04-Ala-580,880-46.5/46.9, 35.2/35.4
04-4A4104
ACSTP-43Z1(001)

Addendum No. 2

This addendum is being issued to the contract for construction on State highway in ALAMEDA COUNTY IN OAKLAND AT THE ROUTE 580/880 SEPARATION.

BENT MB 18 AND BENT MB20 ELEVATION

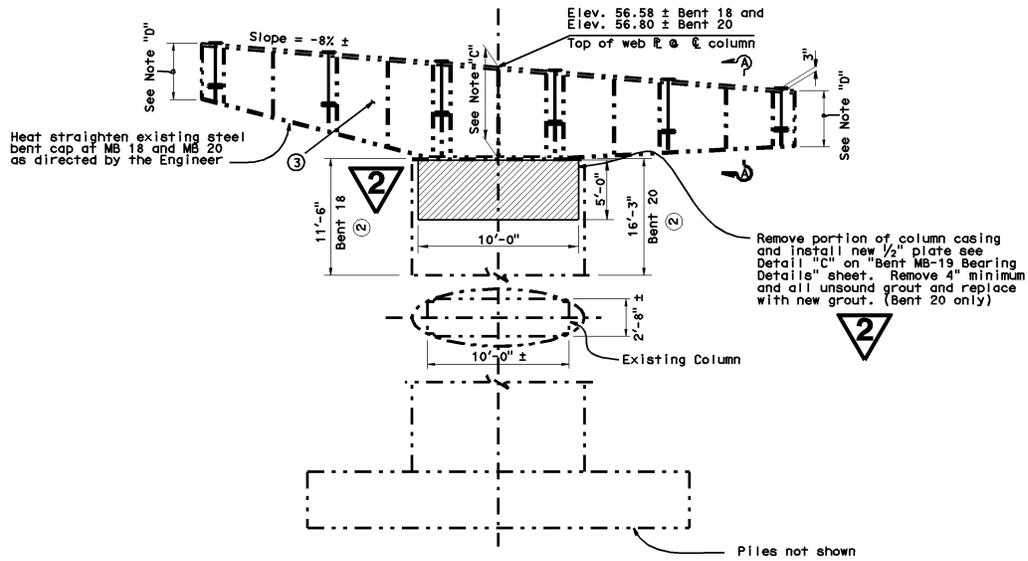
Project Plan Sheet 15, "BENT MB 18 AND BENT MB20 ELEVATION" view is revised as attached.

2 REVISED PER ADDENDUM No. 2 DATED MAY 5, 2007
